**Official Transcript of Proceedings**  
**NUCLEAR REGULATORY COMMISSION**

Title: Advisory Committee on Reactor Safeguards  
Non-Power Production and Utilization Facilities

Date: Wednesday, February 16, 2022

Overview of SHINE Medical Isotope Production

# Process Overview

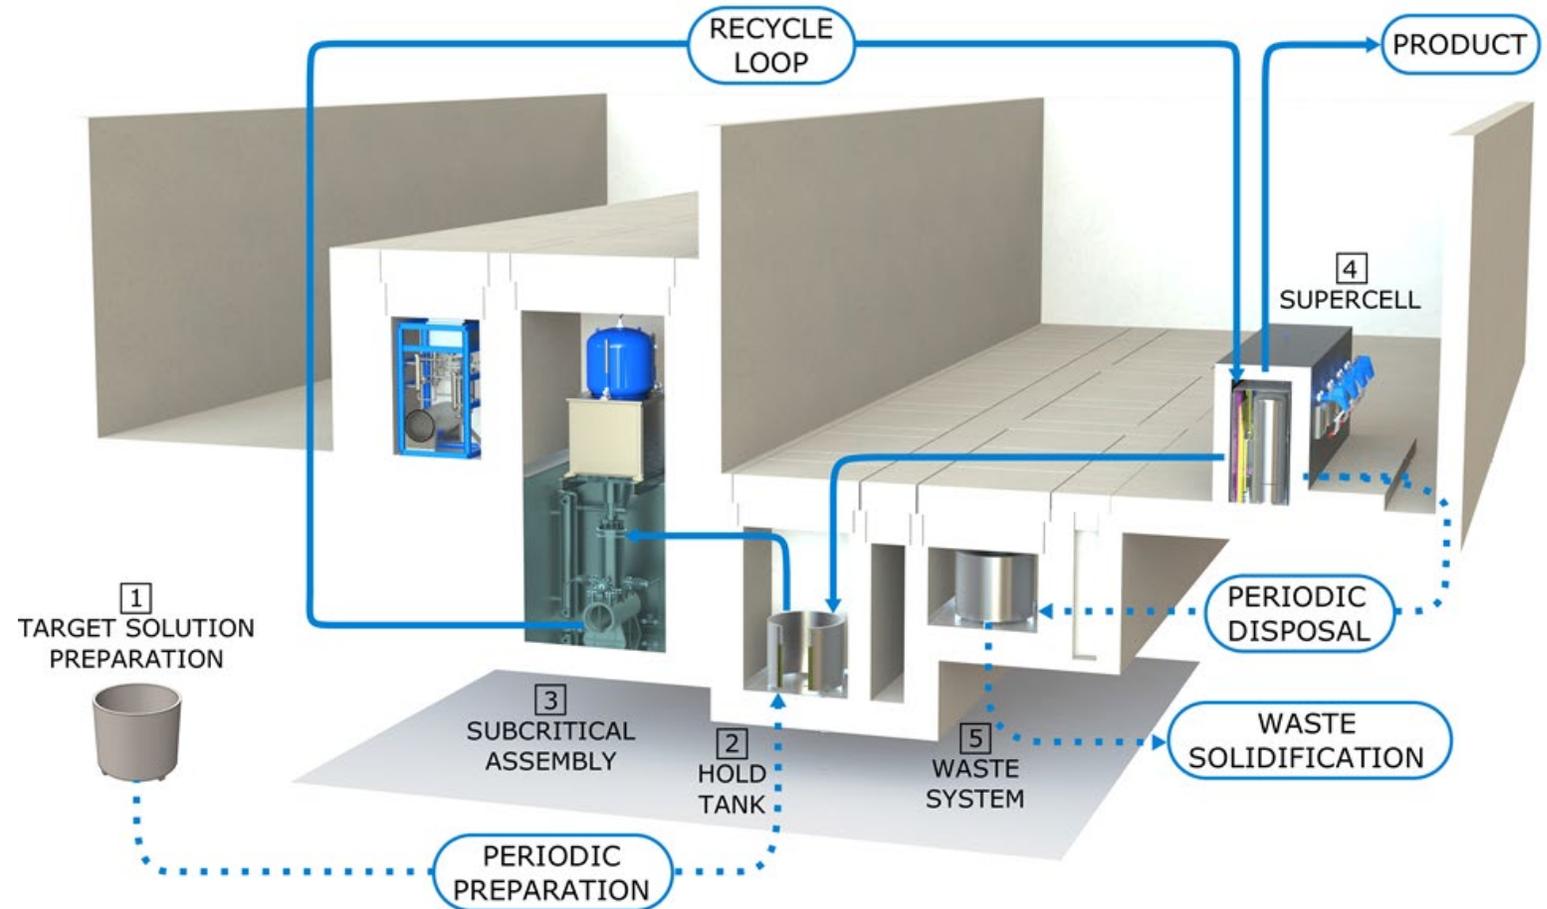
9 MEMBER BROWN: A learning curve again.  
10 The blue line coming out of the supercell and then  
11 back into the hold tank, you talk only about the waste  
12 periodic disposal part of it. You didn't mention what  
13 stuff goes back into the hold tank, if anything.

2 MEMBER MARCH-LEUBA: I just have a short  
3 question. All the holding tanks, they're really  
4 criticality safe volumes, correct? They're really  
5 annulus because they look like a big 55-gallon drum,  
6 but you only store material under the skin, correct?

21 MEMBER HALNON: This Greg Halnon. A real  
22 quick question. Is the only access to the holdup tank  
23 and the annulus next to the right which is a valve  
24 pit. Is it the missile shield's removal? Is that the  
25 only access to those areas?

14 MS. RADEL: Yes, sorry. So the target  
15 solution passes through the extraction column and  
16 flows then back into the hold tank. So the process  
17 doesn't alter the target solution and so it goes right  
18 back to the hold tank for another irradiation cycle.

7 MS. RADEL: Right, they're annular tanks,  
8 favorable geometry.

1 MS. RADEL: The only access is through the  
2 cover plugs.
